To: Members of the City Planning Commission  
From: Robert Dobruskin RD  
Date: September 1, 2017  
Re: **NYU Core – 181 Mercer Street Modification**  
CEQR No. 11DCP121M  
ULURP No. M 120124(A) ZSM  
SEQRA Classification: Type I

**TECHNICAL MEMORANDUM 003**  
**NYU CORE**  
**CEQR No. 11DCP121M**  
**ULURP No. C 120124 ZSM**

E-W Section through 181 Mercer Street  
 Building Elements G and H  
 View North  
**Figure 11**

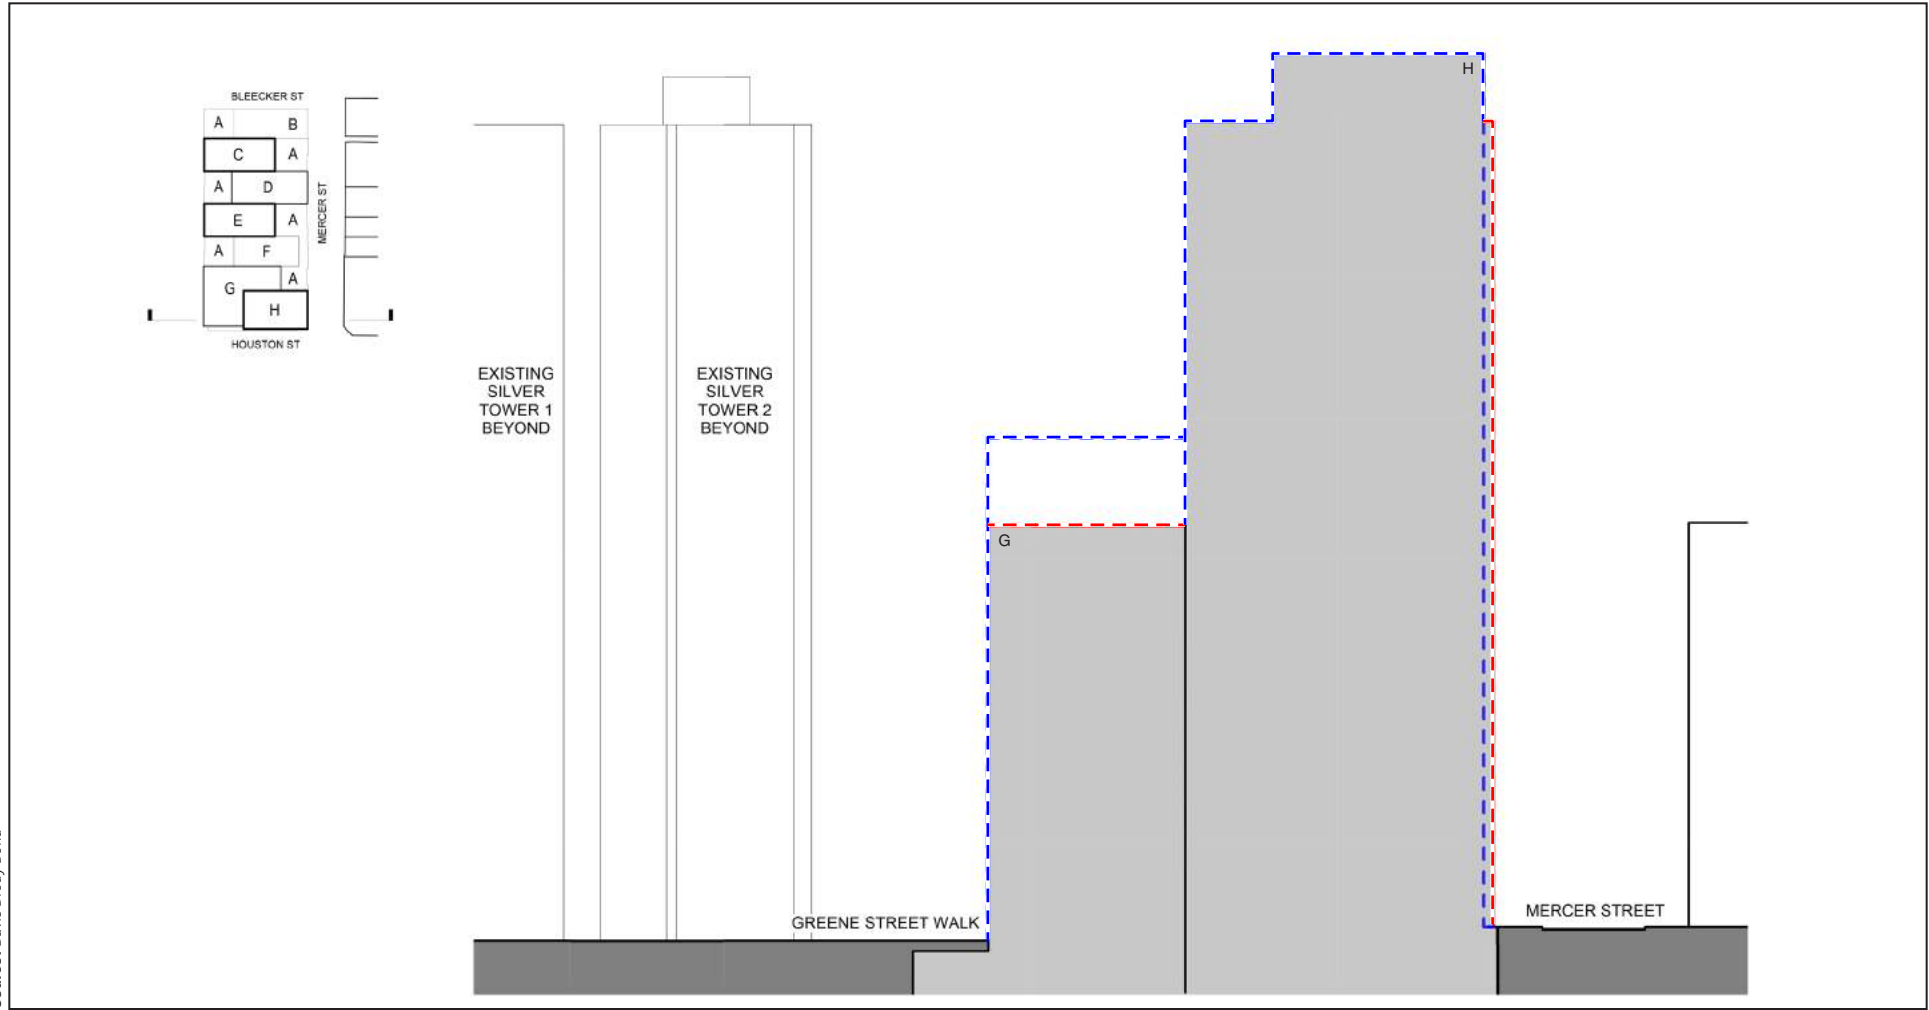
The maximum permitted envelope for the 181 Mercer Street Building’s “H” tower would be adjusted as follows (see **Figures 10 and 11**):

- Decrease the 6-foot setback from Mercer Street of the southernmost portion of the “H” tower (with 32 feet of frontage along Mercer Street) by 3.5 feet, resulting in a minimum setback from Mercer Street of 2.5 feet. This setback adjustment would occur from ground-level up to and including the top floor of the southern portion of the “H” tower.
- Increase the setback from Mercer Street of the northern-most portion of the “H” tower (with approximately 31 feet of frontage along Mercer Street) to 2.44 feet from ground level to 85 feet in height and to 13.22 feet above 85 feet in height.
- Reduction in the bulk of the western façade of the “H” tower.
- At the base of the “H” tower along West Houston Street, increase the setback of the maximum permitted envelope from 1.72 feet to 3.98 feet.

There would be no change to the required setback of the “H” tower bulkhead. The setback adjustments along Mercer and West Houston Streets would better align the southern portion of the “H” tower plinth to optimize the exterior circulation space at the podium level and the configuration of the faculty apartments in the tower portion. These setback modifications would not increase the maximum permitted floor area for the 181 Mercer Street Building.

With respect to zoning, the Proposed Modification includes a 3.5-foot eastward extension of the approved Special Permit height and setback waiver along Mercer Street for the southern portion of the “H” tower (as shown on Special Permit drawing Z-133). This change is small and would more closely align the southern portion of the “H” tower plinth with the northern portion of the “H” tower plinth. The increased height and setback waiver for the southern portion of the “H” tower would be offset by a decreased height and setback waiver for the northern portion of the “H” tower. Above the 85-foot plinth level, the originally approved Special Permit drawings for the “H” tower provide for 35 feet of frontage to have a setback from Mercer Street of 6 feet and 30 feet of frontage to have no setback; the modified drawings for the “H” tower above the plinth would require 31 feet of frontage to have a setback from Mercer Street of more than 13 feet and 32 feet of frontage to have a 2.5-foot setback. As described in the 2012 FEIS, the height and setback waiver for the “H” tower facilitates an eastward shift of the building’s mass in order to accommodate the Greene Street Walk along the building’s western façade, improving connectivity through and across the site and supporting the activation of Mercer Street by engaging the sidewalk. The 3.5-foot extension of the approved Special Permit height and setback waiver for the southern portion of the “H” tower would accommodate the design modification to the “H” tower, and would continue to be consistent with the intention of the waivers. Furthermore, the Proposed Modification changes to the “C,” “E,” and “G” towers and all of the substantial compliance changes would comply with the height and setback regulations of the underlying zoning district and the Design Guidelines for the building specified in the Special Permit drawings. For these reasons, consistent with the findings of the 2012 FEIS and subsequent Tech Memos, the Proposed Modification inclusive of the substantial compliance changes would not result in significant adverse impacts with respect to land use, zoning and public policy.

E-W Section through 181 Mercer Street  
Building Element G  
**Figure 20**

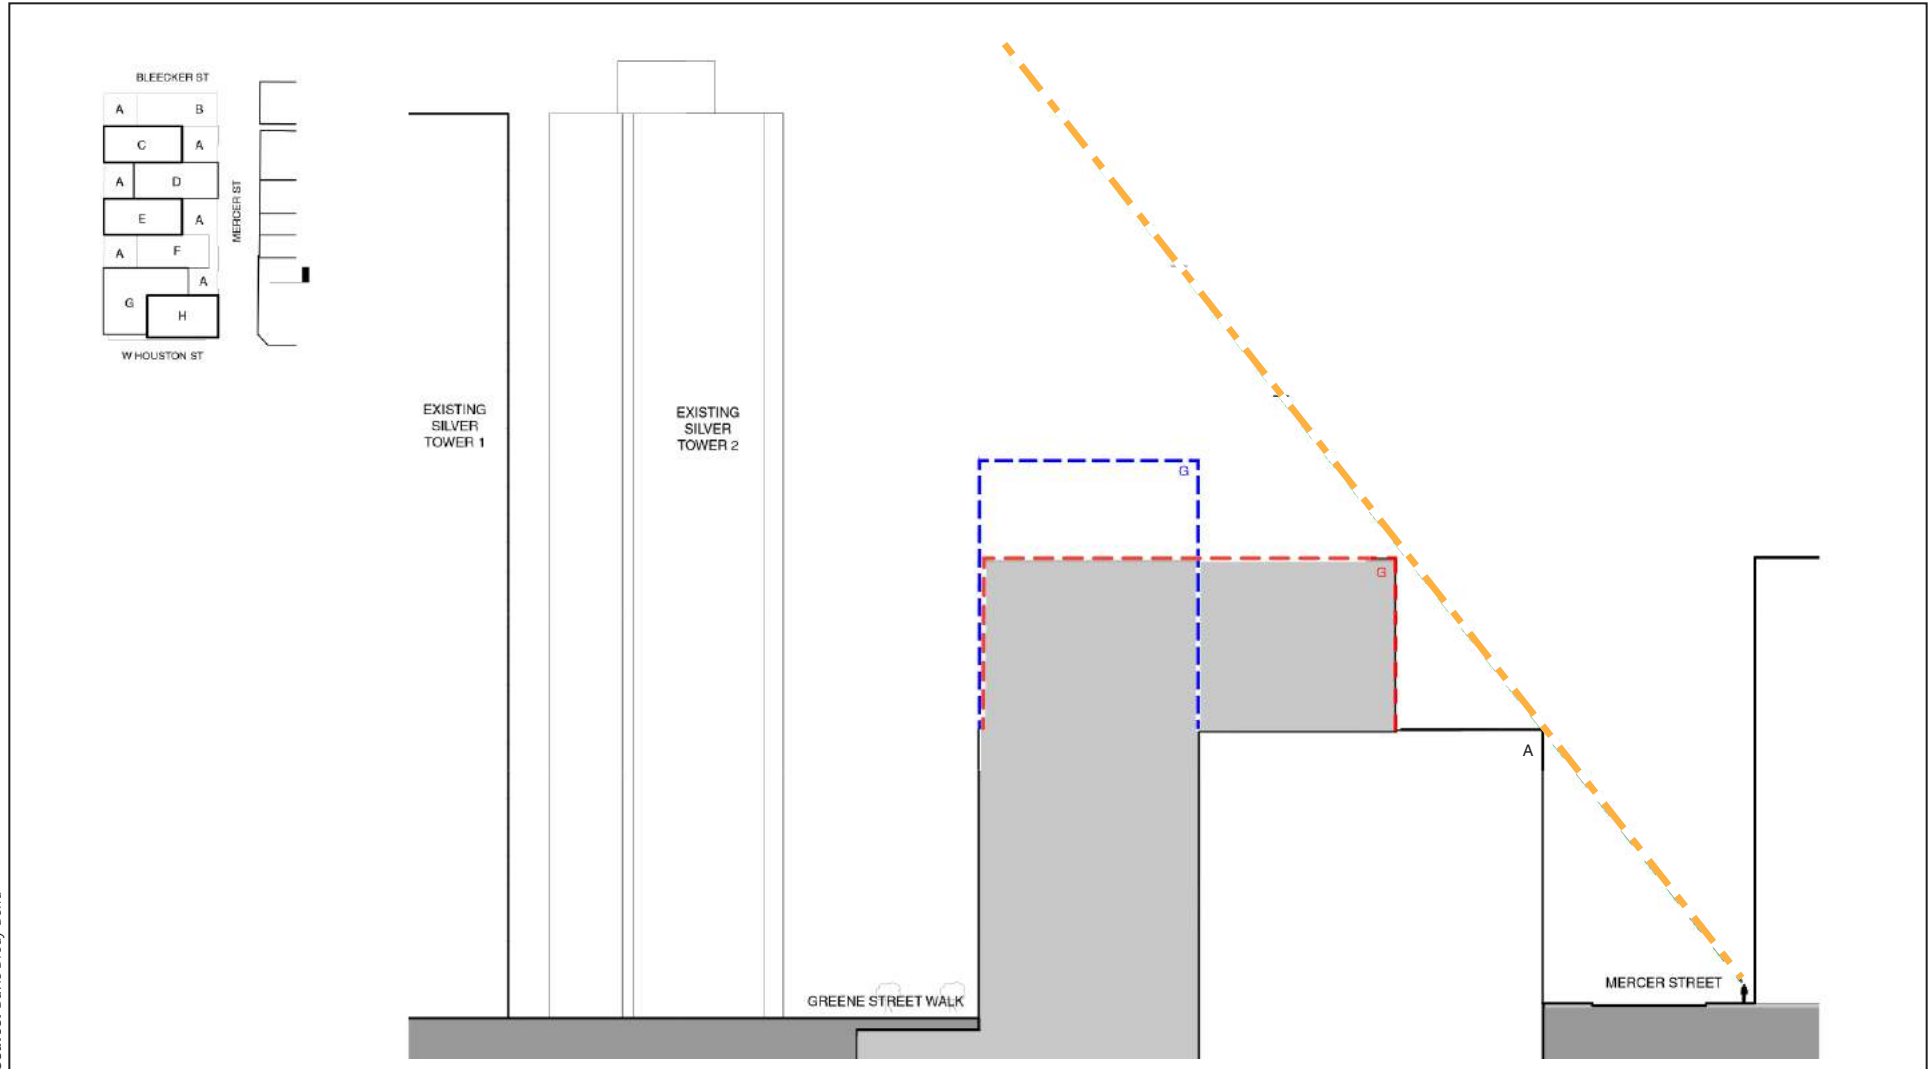
Similar to the massing shown in the Special Permit drawings, with the Proposed Modification inclusive of the substantial compliance changes the “C” and “E” towers would be visible from the eastern sidewalk of Mercer Street north of West Houston Street. The eastward adjustment of the towers would make them more visible from this pedestrian viewpoint, but the adjustment would be within the height and setback requirements of the underlying zoning, and would not adversely affect any elements of urban design. The “G” tower with the Proposed Modification would not be visible from the sidewalk on Mercer Street north of West Houston Street because it would be located on top of the 85-foot tall base of the building and would be setback at a depth of 46 feet from Mercer Street (see **Figure 20**).
